Architectural Control Committee
Plan and Specification Review Determination
Roofing Application

Architectural Control Committee Plan and Specification Review Determination Fence Application (Page 1 of 3)

Scope of work for Trent
Graves Residence
3-9-12

Subject: **Landscape removal – comments on shake roofs**
Amberleigh

Existing Site plan and Fence location

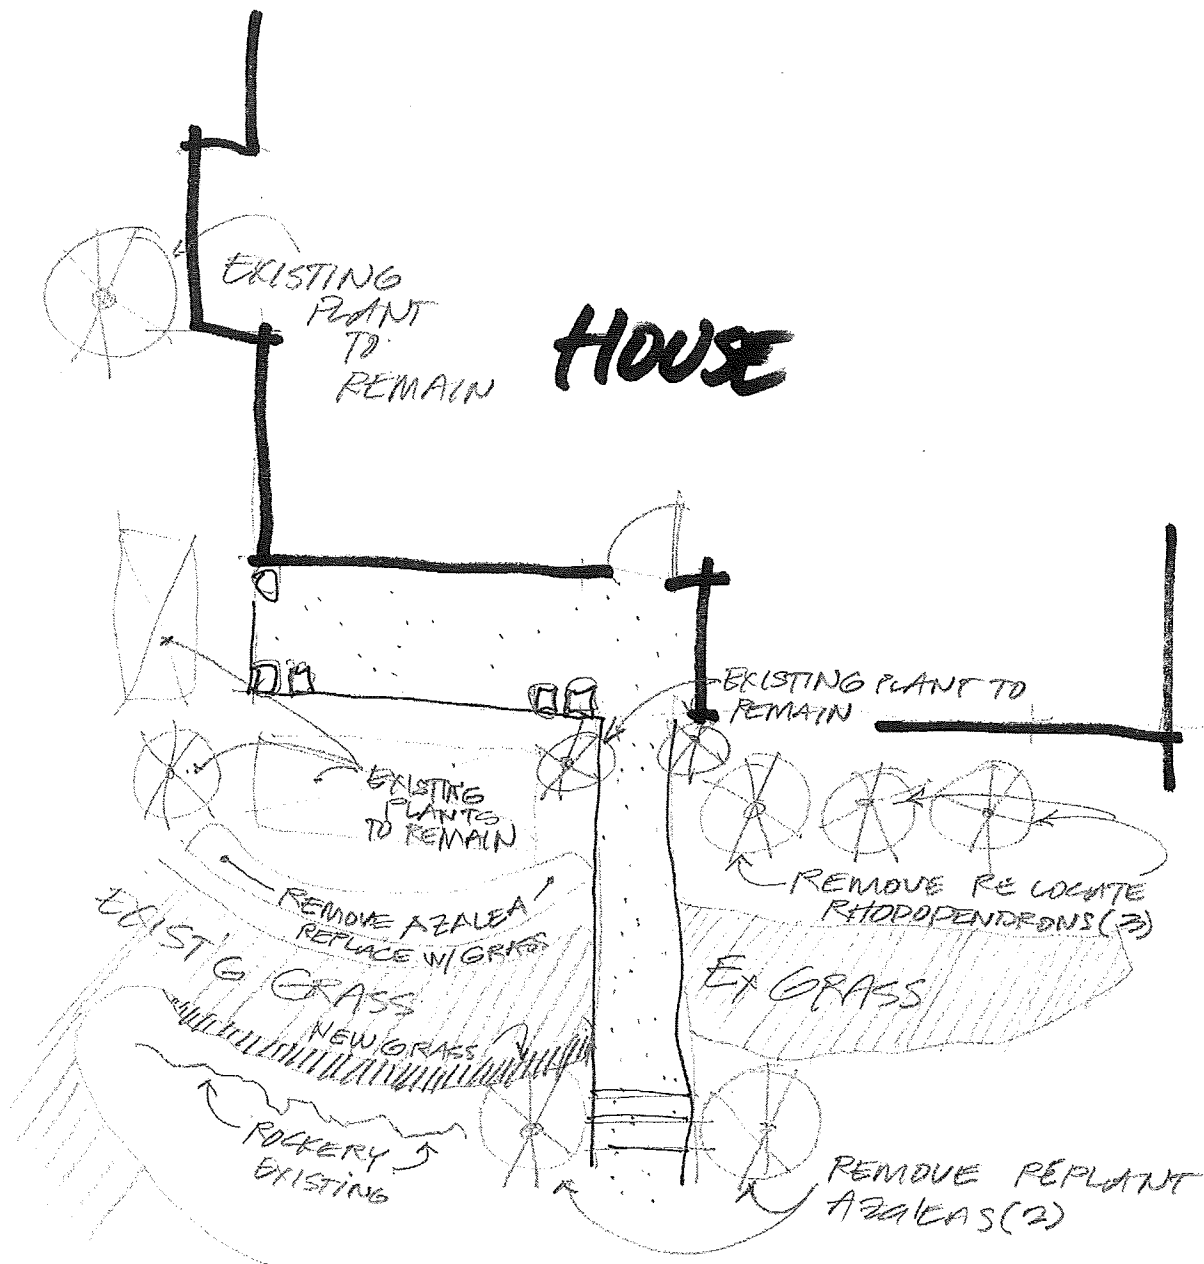
Remove and replant front of house rhododendrons (3)
Replant on North side of house
Remove and replant entry sidewalk Hydrangeas (2)
Replant on North side of house
Remove ground cover
Remove front of house azalea 15LF
Replant grass

there is no problem with what you want to do
you have approval

Encl: Site plan of Graves's lot (16311 18th Ave SE)

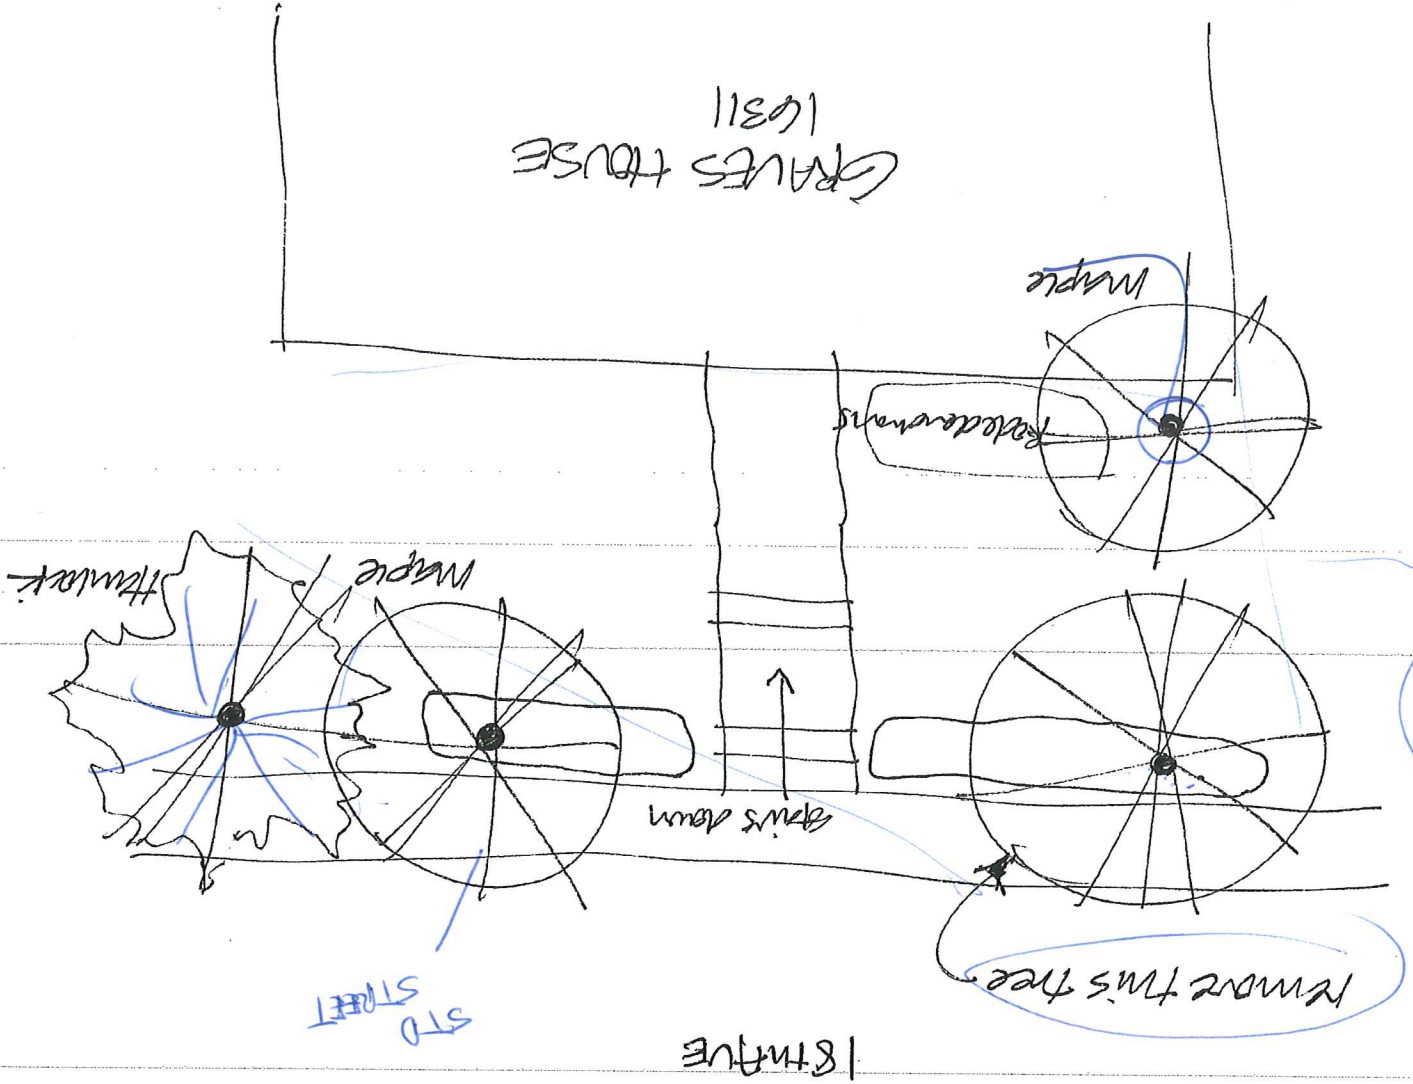
I understand from Michael Beaumont that all Amberleigh landscaping jobs are the decision of the HOA board? The three trees along the sidewalk have now all matured and block most of the sunlight during the spring, summer and early fall. We would like the board to consider removing the southern most deciduous tree near the side walk on our lot. It was also damaged from heavy snows last spring. Thank you for your consideration on this matter.

SITE PLAN

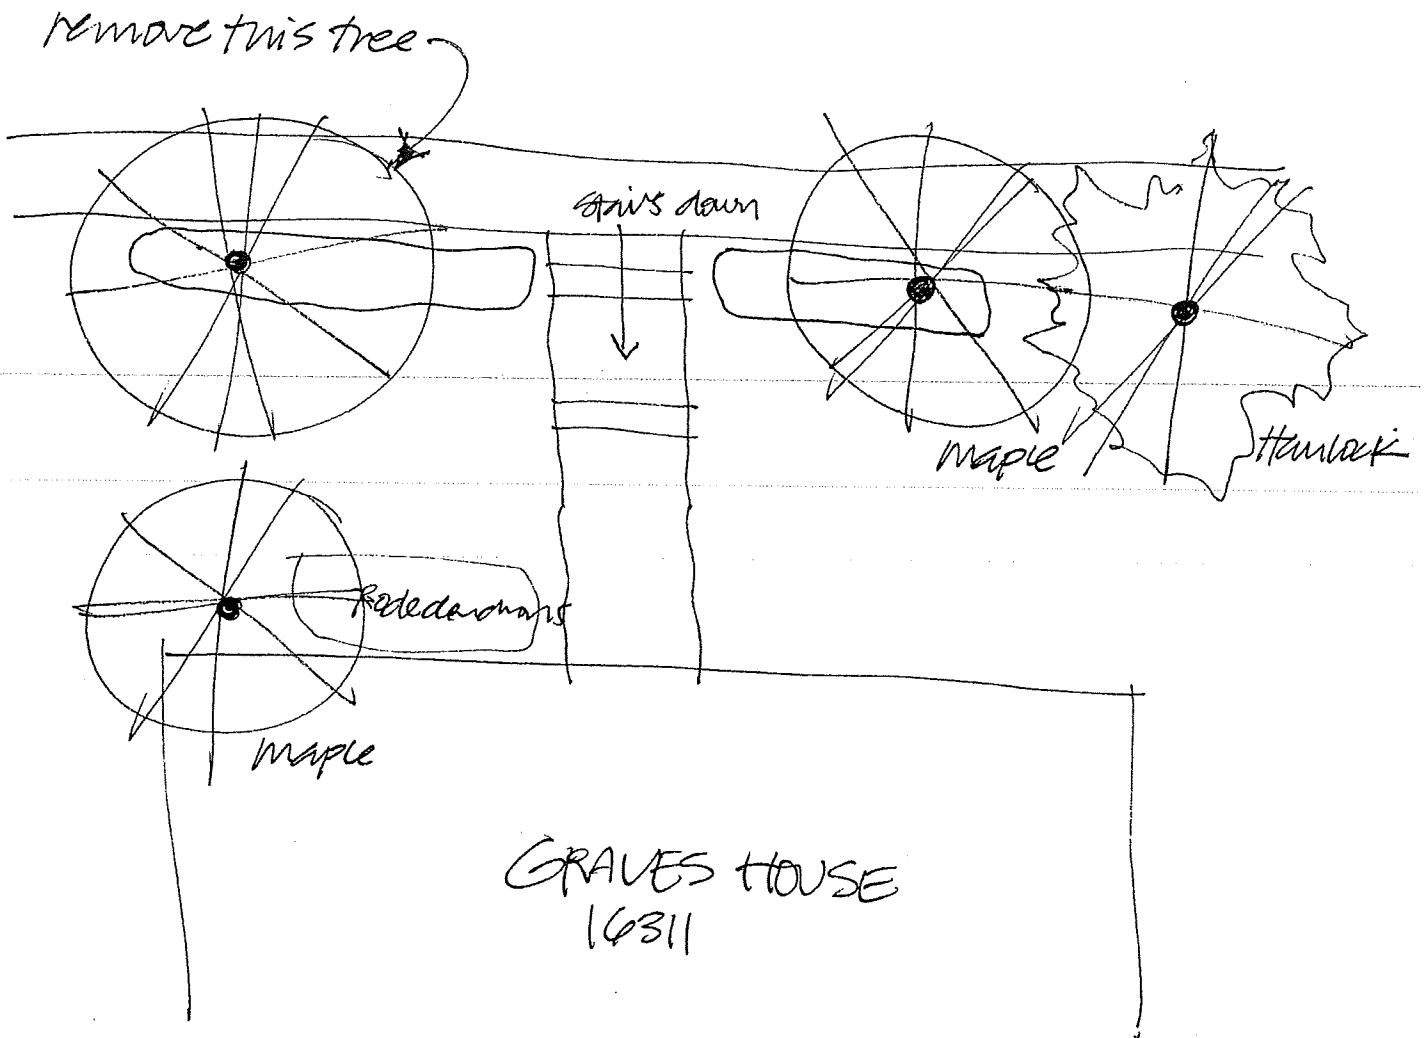
I understand from Michael Beaumont that all Amberleigh landscaping jobs are the decision of the HOA board? The three trees along the sidewalk have now all matured and block most of the sunlight during the spring, summer and early fall. We would like the board to consider removing the southern most deciduous tree near the side walk on our lot. It was also damaged from heavy snows last spring. Thank you for your consideration on this matter.

remove this tree

- approved.
- HOA will handle.
